<b>Delegated Report (Members Briefing)</b>	<b>Analysis sheet</b>	<b>Expiry Date:</b>	<b>20/05/2020</b>
	N/A / attached	<b>Consultation Expiry Date:</b>	<b>15/06/2020</b>
<b>Officer</b>		<b>Application Numbers</b>	
Mark Chan		2020/1462/P	
<b>Application Address</b>		<b>Drawing Numbers</b>	
196-198 Haverstock Hill London NW3 2AG		Please refer to decision notice	
<b>Proposals</b>			
Relocation of plant equipment and installation of 2x condenser units and extract fans and associated ductwork to roof level of rear extension (Part-retrospective).			
<b>Recommendations:</b>	Grant conditional planning permission		
<b>Application Types:</b>	Full Planning Permission

## Assessment

Figure 1: Proposed Rear Elevation

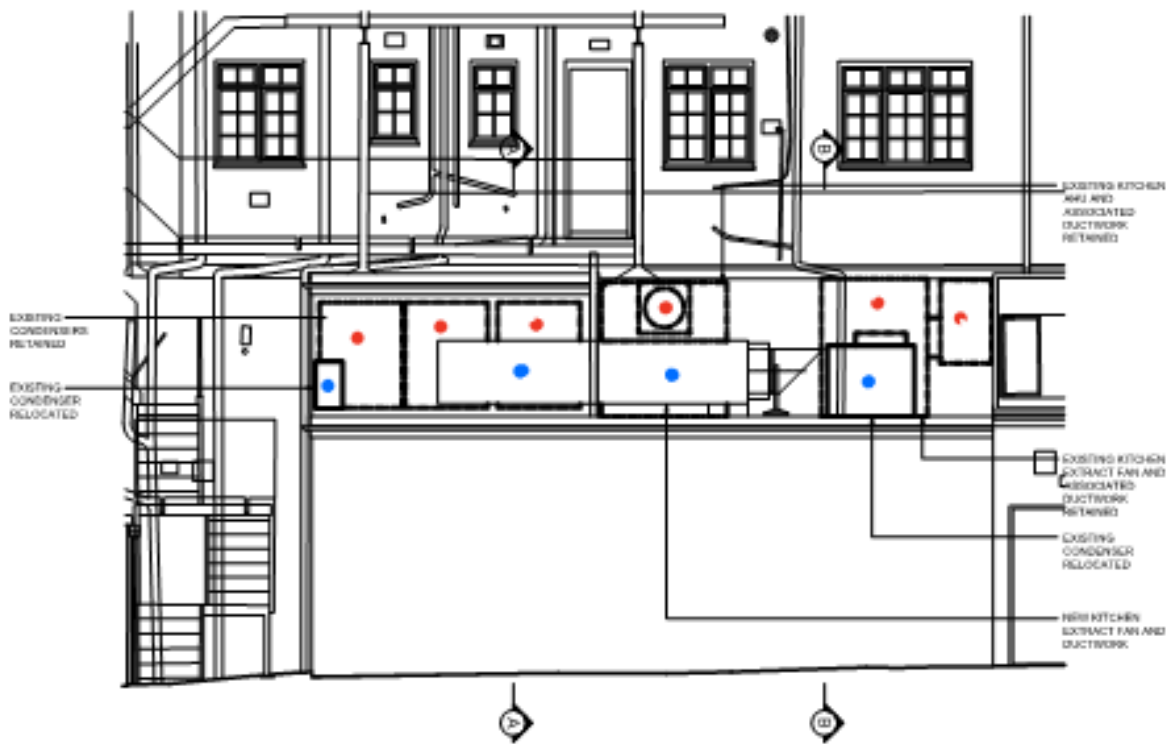
4.4 The current application is to rationalise the rear roof plant re-arrangement and installation of new condenser units. The rearranged plant and new condenser units would be installed at the rear of the existing rear extension which is half a storey lower level than the main roof of the rear extension. On the side elevation of the existing rear extension, only the consented existing gas meter enclosure would be retained. The existing condensers on the side elevation would be removed and relocated onto the flat roof at the rear of the rear extension. On the roof of the rear extension, the existing kitchen air handling unit and associated ductwork would be retained and so would be the existing kitchen extract fan and associated ductwork. The three existing condensers on the roof would also be retained and two additional condenser units would be installed. In addition to the condensers, new kitchen supply and extract fans and ductwork would also be installed. The applicant has stated that it would avoid the additional cost of installing new plant equipment and condensers but this is the minimum amount to maintain the operating efficiency of the kitchen and to operate within the HSE guidelines and the environmental and acoustic requirements of the local authority.

4.5 The plant equipment and condenser units are located predominantly on the flat roof above the rear extension. The proposal does not increase the height of the rear extension and would not be visible to the streetscene. Given that plant equipment and condensers already exist on the roof of the rear extensions of other shops on this parade, the proposal is considered to be in keeping with the character of the area and is no more visually intrusive than previously consented plant installation on the application site or adjacent properties. There are no public views of this part of the property and private views from the residential flats on upper floors of the site are limited and restricted given that the proposal is below and away from the rear windows of the flats. Overall, it is considered that the proposal may cause minor harm to the visual amenities, but due to the rear location and back of the site having a lot of plant equipment already, it is considered, on balance that the proposal is acceptable in design terms, in accordance with policy D1 of the Camden Local Plan.
